Coupling attenuation and EMC considerations

Draft 1.2 Comments #363 and #364

Dieter Schicketanz
Reutlingen University

Typical measurement

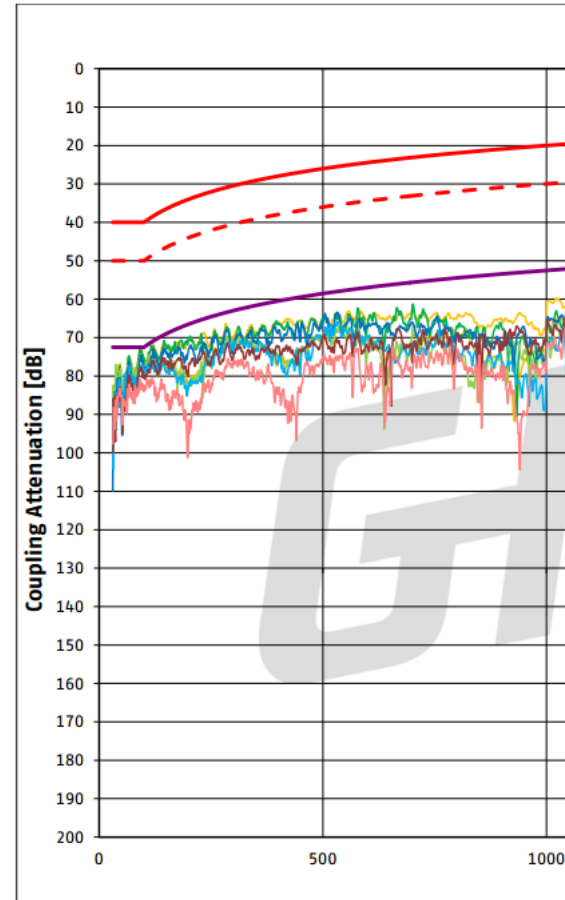
The graph was created using IEC 62135-4-13 and shows the typical slope of 20dB/decade. It can be seen that it shows this behaviour below 100 MHz but the standard neglects this. Therefore the formula is for this case:

$$CA = 112 - 20 \log(f) \quad 72 \text{ dB max} \quad 30 < f < 1000 \text{ MHz}$$

But the measured maximum is 78 dB at 30 MHz.

Example of a measurement down to 150 kHz

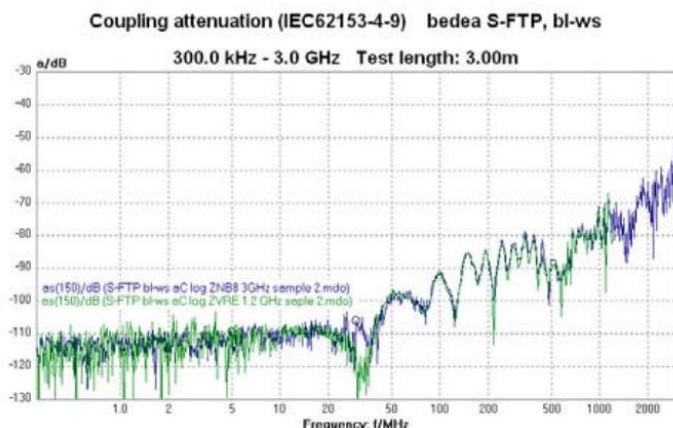
-
- There are various IEC standards to measure coupling attenuation down to less than 1 MHz, but not referenced by cabling and component standards.
 - A list can be seen after page 12. Coupling attenuation not always mentioned in the title

Coupling attenuation (IEC62153-4-9) bedea S-FTP, bi-ws

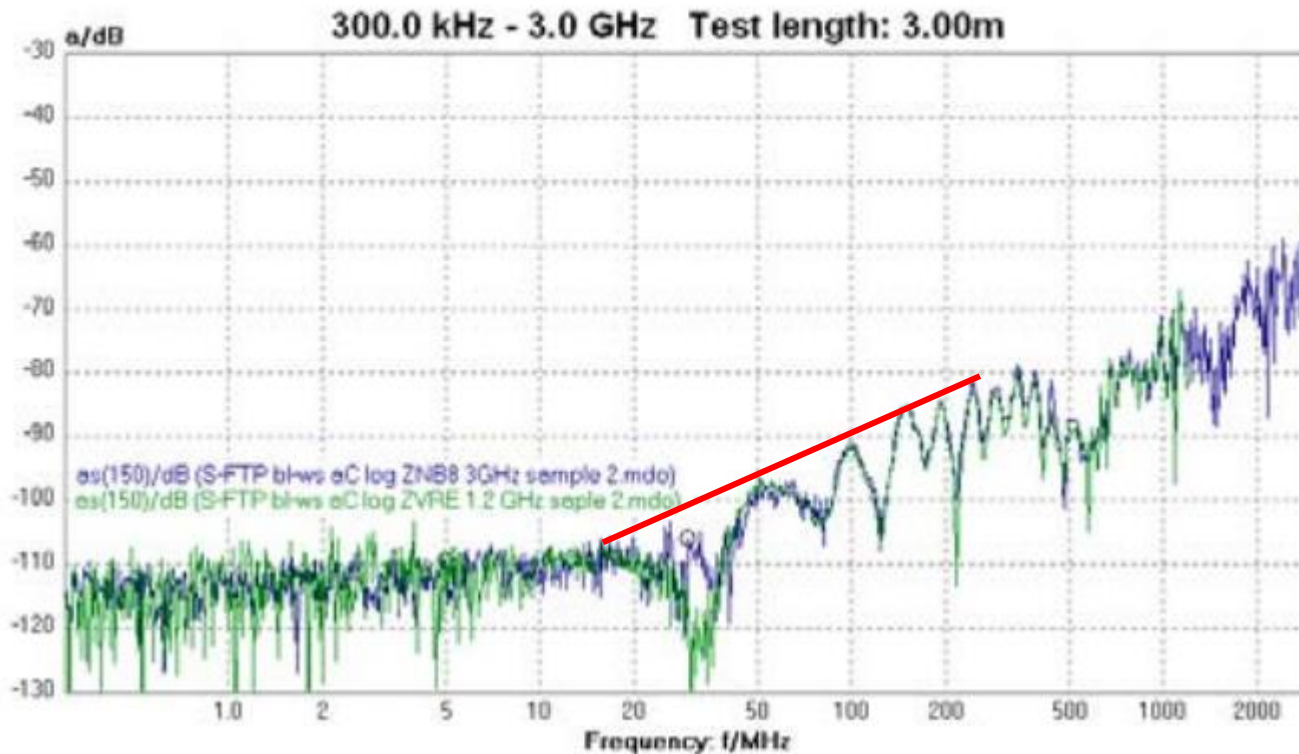
Is a 20 dB/dec line showing that till 15 MHz it follows this slope .
It is therefore save to use the 100 MHz value for coupling attenuation from
150 Khz to 20 MHz for the T1L link.

- Therefore values of coupling attenuation using the actual 30 MHz values should be used.
- Table 146-6 would then be:
- Reference: TBD

Frequency (MHz)	E_1 dB	E_2 dB	E_3 dB
$0.1 < f \leq 20$	40	50	60
